NHTSA SAFETY RECALL

Safety Recall Notice # _____ EHC Replacement

2006 K-9 EHC REPLACEMENT Recall 06V-XXX

EHC COMPARISON

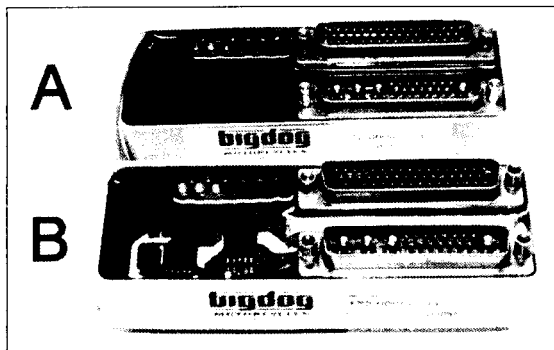
IMPORTANT: Replace the EHC of ANY Big Dog Motorcycle model having an EHC, P/N 170-000001-00 with clear, gel-type potting material. Remove that EHC and replace with P/N 171-000010-00.

NOTE: This recall does not affect EHC's P/N 170-000001-00 with black potting material.

A. 170-000001-00 with black potting material.
B. 170-000001-00 with clear potting material.

TYPICAL – Fill these areas (1) to top of pins with dielectric grease, filling all areas (2) to remove air gaps.

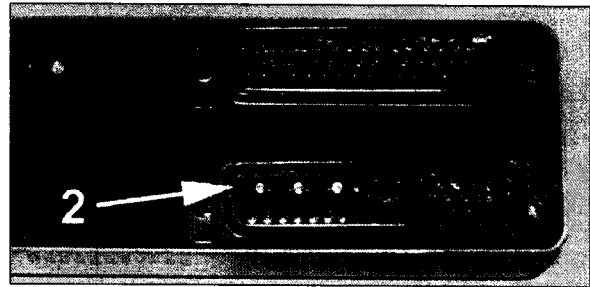
3. Unscrew the four connector screws from the backbone and power harnesses and pull the two connectors off and away from the EHC.
4. Remove the two nylon nuts from the EHC studs and remove the EHC.
5. Inject dielectric grease (P/N 270-000009-00) into the power and backbone harness connector ports of the replacement EHC. Fill to top of pins. Smooth dielectric to remove air gaps.

NOTE: Install in reverse order, making sure that the two nylon nuts are not tightened more than 15 in•lbs. Harness connector jack screws should be tightened evenly from side to side until the connectors seat.
